TECHNICAL EVALUATION REPORT

REVIEW OF LICENSEES' RESOLUTION OF OUTSTANDING ISSUES FROM NRC EQUIPMENT ENVIRONMENTAL QUALIFICATION SAFETY EVALUATION REPORTS (F-11 and B-60)

ALABAMA POWER COMPANY
JOSEPH M. FARLEY NUCLEAR PLANT UNIT 2

NRC DOCKET NO. 50-364

Figure 4-1. Solenoid Valve (Licensee Figure 1)

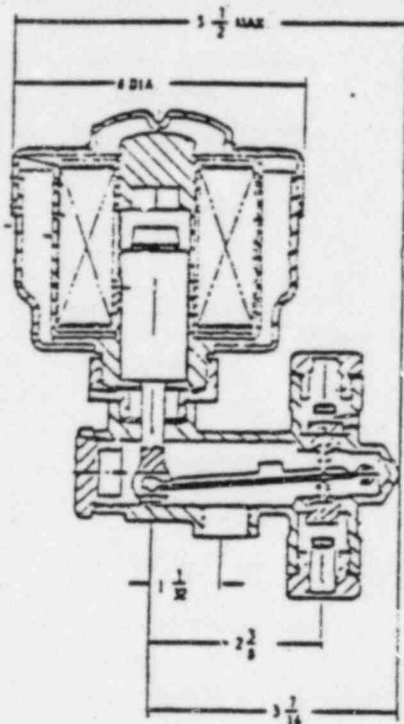
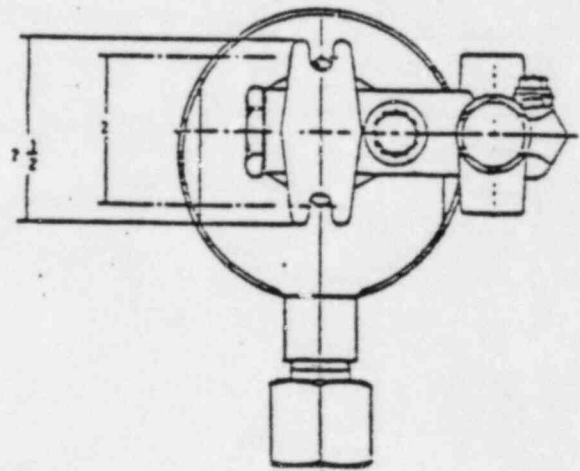
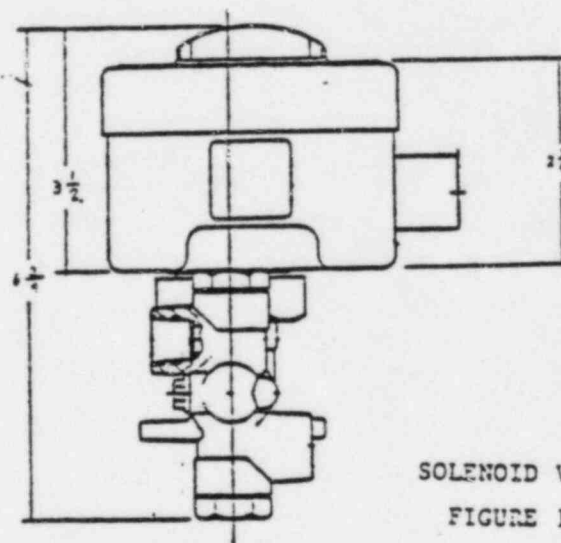
As an example of the modeling techniques used, the model of a three-way direct-acting solenoid valve manufactured by the Automatic Switch Company is presented in this section. This solenoid valve is typical of those in the Farley containment. Figure 1 [Figure 4-1 of this TER] shows several scaled views of the component including its internal construction. The critical region to be analyzed here is the upper housing, a four inch diameter circular cylinder, which contains the core assembly and coil used to energize the valve.

Figure 4-2. Solenoid Valve (Licensee Figure 2)

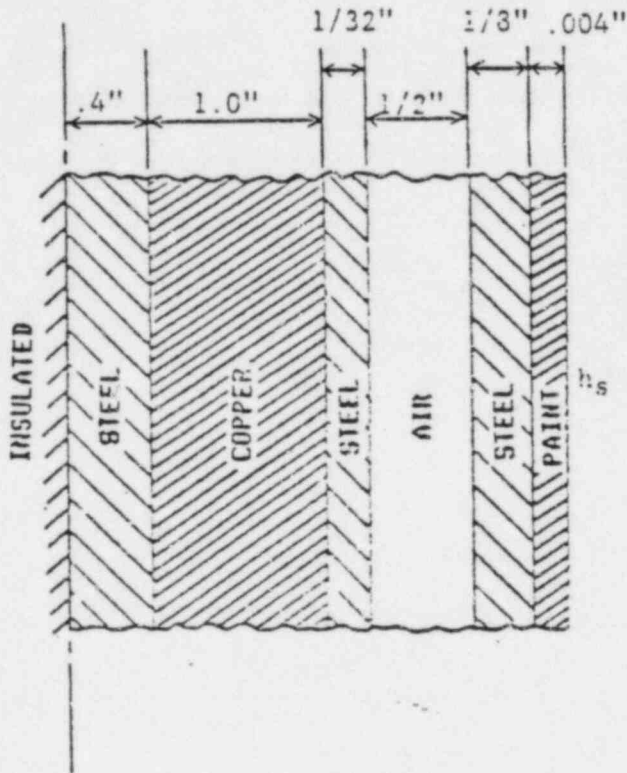
Figure 2 [Figure 4-2 of this TER] is a diagram of the valve, modeled as a cylinder with the center line on the left and the cylinder surface on the right. The material regions from left to right correspond to the steel core assembly with 15 nodes, the copper coil with 10 nodes, the steel coil housing with 10 nodes, the air gap separating the coil and housing with 40 nodes, and the painted steel upper housing with 15 nodes in the steel and 5 nodes in the paint.

Typical thermal conductivities and volumetric heat capacities for each material are also given in Figure 2. The valve's characteristic length of 2.75 inches, the height of the solenoid valve, is used in the calculation of the time dependent convective heat transfer coefficient described in section IIb. As the component is symmetrical, left side centerline boundary condition is insulated (no heat transfer). The right side surface is exposed to the containment MSLB atmosphere.

The component's temperature distribution is hence calculated by the COPATTA computer code for limiting MSLB transients. From this, the maximum surface temperature of the component can be identified and used to determine if a component is qualified for the MSLB environment.

FIGURE II.C.-2
TYPICAL LIMIT SWITCH "SEAL-IN" CIRCUIT
FOR CONTAINMENT ISOLATION VALVE

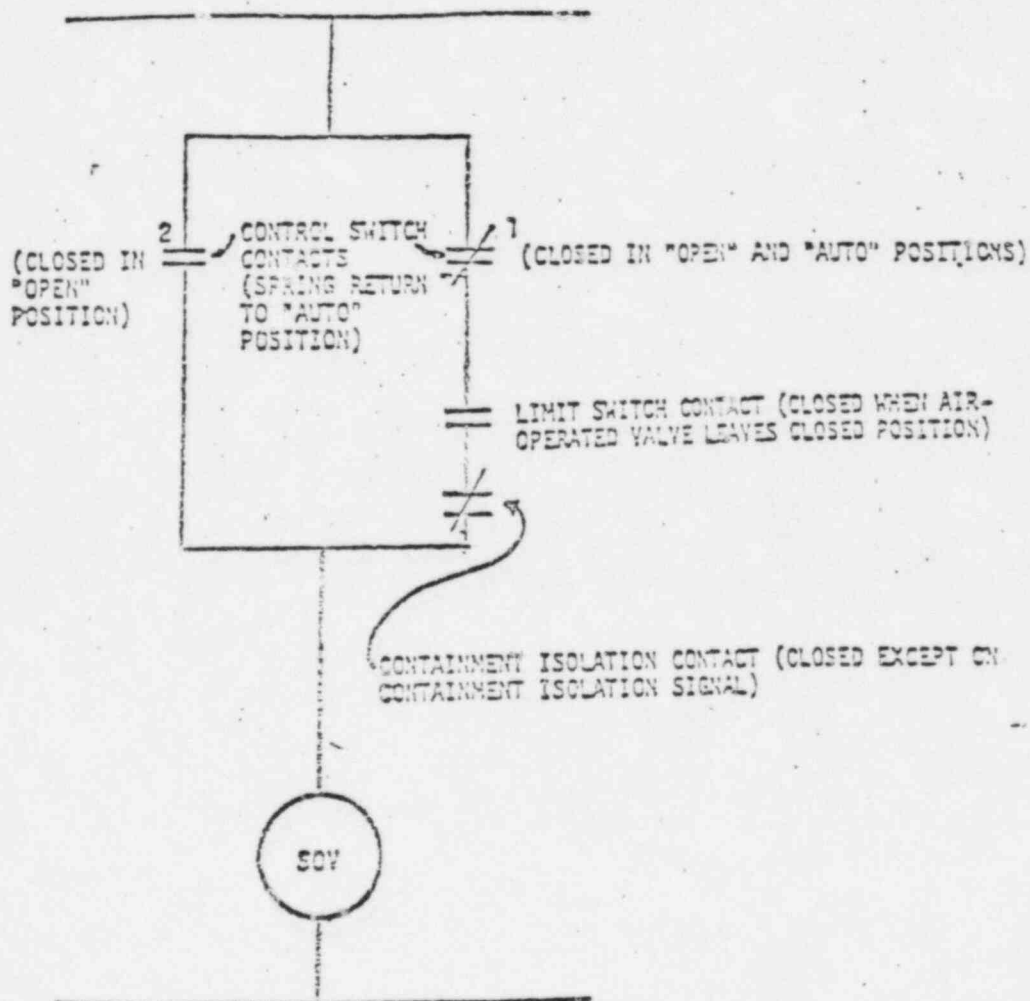
EQUIPMENT ENVIRONMENTAL QUALIFICATION REVIEW OF EQUIPMENT ITEM NO. 26
